MILITARY SPECIFICATION

LOUDSPEAKERS, PERMANENT MAGNET, BIASTPROOF
AND SUBMERSIBLE, NAVY TYPE 4954b ()

This amendment forms a part of Military Specification
MIL-L-16225B(SHIPS), dated 12 January 1961.

MIL-L- 16225B(SHIPS)
AMKNDMENT 1

FIGURE 2. Orientation in acoustical tests.

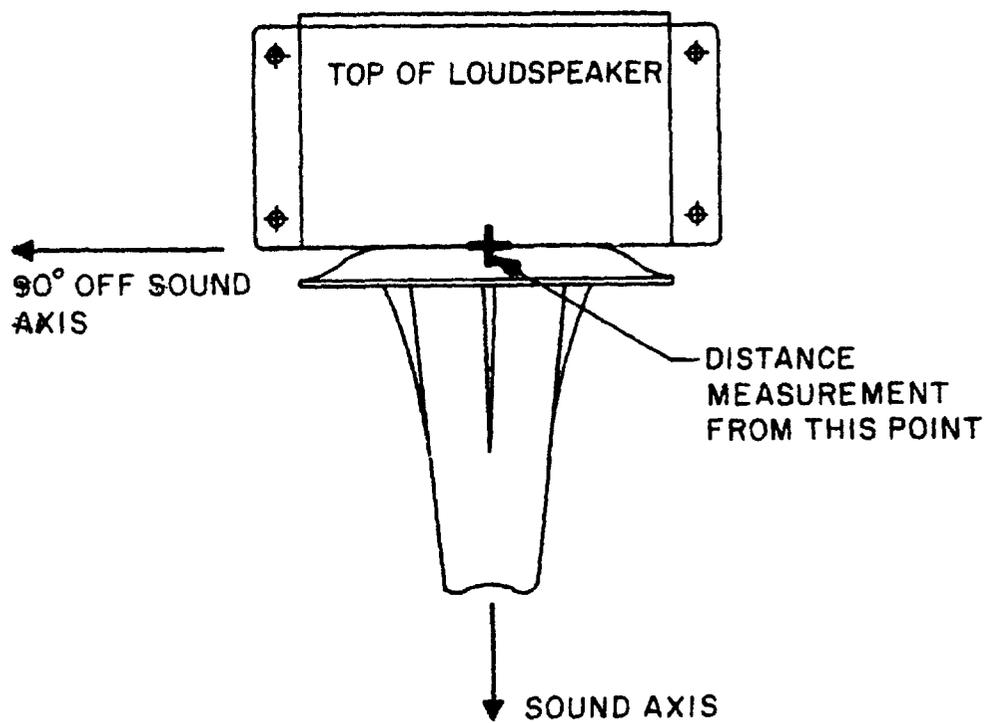
3.6.1, last sentence, delete and substitute: "The frequency response, when
tested 90° off the sound axis (see figure 2) shall be within the limits shown
in figure 1."

Following figure 1, add figure 2 as printed on page 2 of this amendment.
